PCN Number:	20150213002A	PCN Date:	08/10/2015
Title:	F021 - Orderable Part Number Retirement and Replacement		
Customer Contact:	PCN Manager	PCN type:	P/N Retirement
Dept.:	Quality Services		
Last date to order:	02/10/2016	Last date to ship:	08/10/2016

Orderable Part Number Retirement and Replacement Notification Details

Example Product Shipping Label

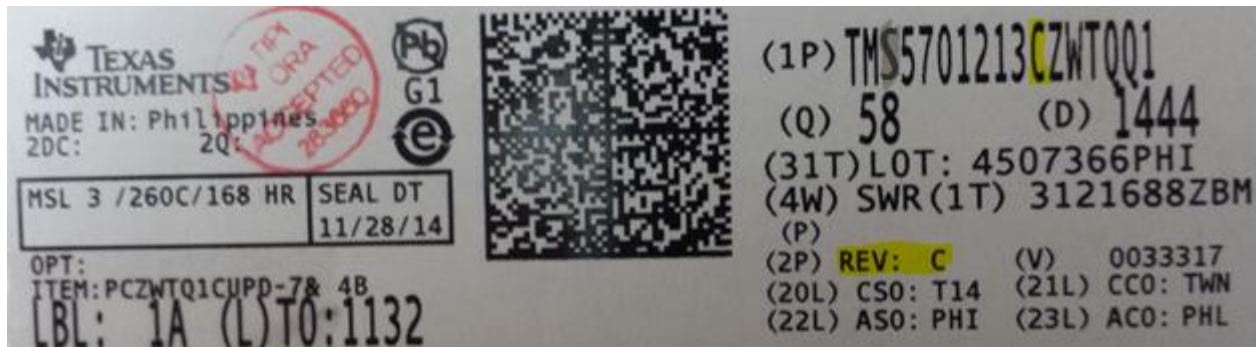
Die Rev designator will change as shown in the packing example label below and is shown in the errata document for each device:

Device Family	New Die Revision
TMS570LS21x/LS31x	D
TMS570LS11x/LS12x	C

TMS570LS03x/LS04x

B
